Project	IEEE 802.16 Broadband Wireless Access Working Group < http://ieee802.org/16 >	
Title	Consolidation of CX Frames format and occupancy rules	
Date Submitted	2007-01-07	
Source(s)	Mariana Goldhamer Alvarion Tel Aviv, 21 HaBarzel Street Israel	Voice: +972 3 6456241 Fax: +972 3 645 6204 mailto:marianna.goldhammer@alvarion.com
Re:	[If this is a proposed revision, cite the original document.] [If this is a response to a Call for Contributions, cite the name and date of the Call for Contributions to which this document responds, as well as the relevant item number in the Call for Contributions. Contributions that are not responsive to this section of the template, and contributions which do not address the topic under which they are submitted, may be refused or consigned to the "General Contributions" area.]	
Abstract	[Description of document contents.]	
Purpose	[Description of what the author wants 802.16 to do with the information in the document.]

Consolidation of CX Frames format and occupancy rules

Figure h40—Coexistence Frame Functionality

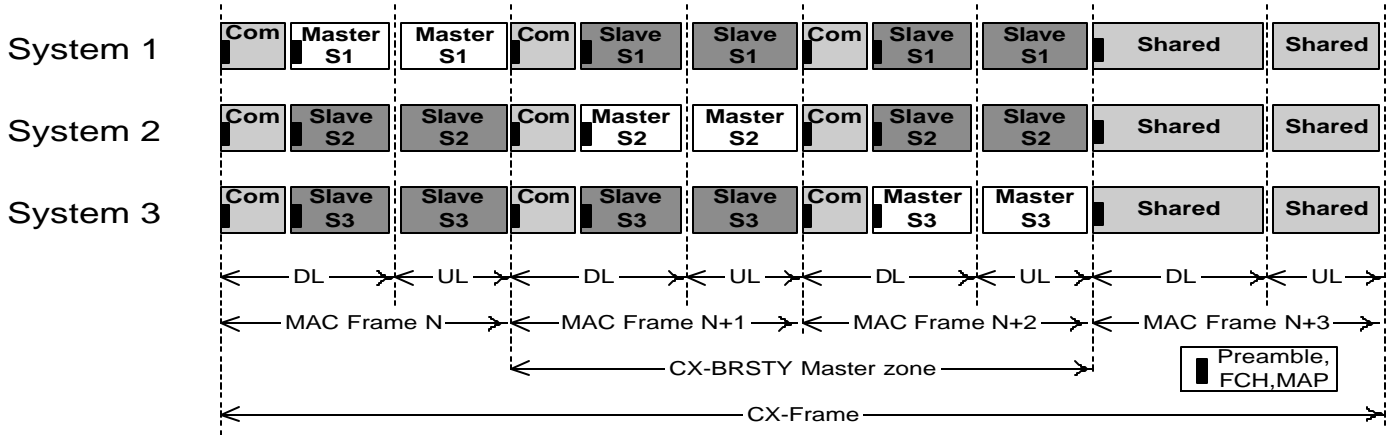
Replace the text in 15.4.2.1.2 starting on page 89, row 4 and ending on page 90, row 28, with the following:

A CX Frame is created by a sequence of four 802.16 MAC frames and it is subdivided into specific sub-frames (see fig, h40).

The CX Frame is composed of Common, Master, Slave and Shared sub-frames, which can be used for DL or for UL. In order to respect the 802.16 frame structure, every MAC Frame starts with a Common sub-frame.

The Common sub-frame is not used in UL.

Figure h41—Sub-frame numbering within the CX Frame

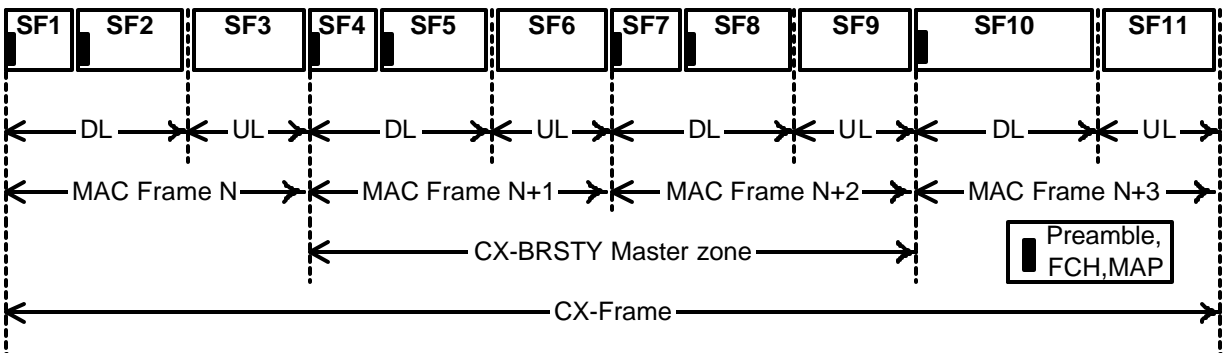
The rules for occupying the Master sub-frames are:

- Only systems synchronized with the GPS or equivalent time source can act as Masters
- The first 802.16h system in an area will use the first Master sub-frame defined in the CX Frame, while the 2nd 802.16h system will use the second Master sub-frame.
- The first Bursty system will use the third Master sub-frame defined in the CX Frame, while the 2nd bursty system will use the 2nd Master sub-frame, if it is not already claimed by a 802.16h system.
- The Master systems will “claim” a Master sub-frame by inserting their Radio signature in the corresponding slots of the CXCC. No system is allowed to claim more than one Master sub-frame.

- If interference is detected during the CXCC slot named “No+I”, SF8 and SF9 will be made available for those system creating the interference. These systems will be considered as the first Bursty system.
A system previously using these sub-frames as Master will have to find another sub-frame which can be used as Master.
